Subject: Questions from Panel regarding trees - 38 Cudgegong Rd, Rouse Hill - JRPP-15-02107 - 2016SYW086

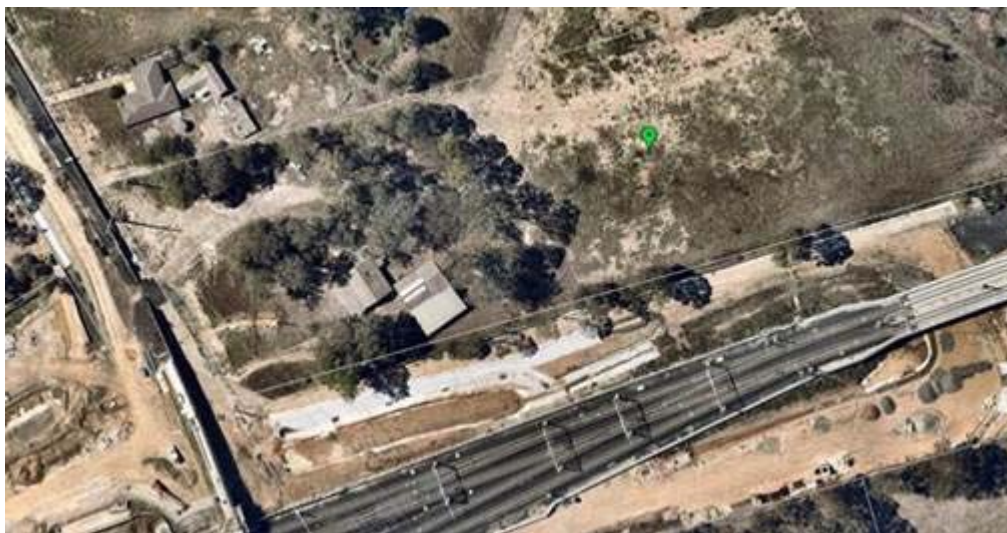
The Applicant has not undertaken any works on their site, however the adjoining site to the south has been subject to extensive works recently by North West Metro Rapid Transit (NRT) being the operations, trains and systems contractor acting on behalf of Transport for NSW, as shown in the extract below from Nearmaps.

As you can see from the current aerial view marked up by the Applicant, the Applicant has reconsidered this matter and have indicated that they could retain these current existing trees along the southern boundary that are not expected to be impacted on by the rail corridor.

We recommend the following conditions are incorporated into the recommended conditions of consent to ensure these trees are protected and retained:

2.1.2 The existing trees indicated for retention on the approved plan titled 'Plan showing extent of zone for existing trees to be retained' prepared by Zhinar Architects and dated 9 March 2018, are to be retained and protected against damage.

9.6.1 The existing trees indicated for retention on the approved plan titled 'Plan showing extent of zone for existing trees to be retained' prepared by Zhinar Architects and dated 9 March 2018, are to be retained and protected against damage.
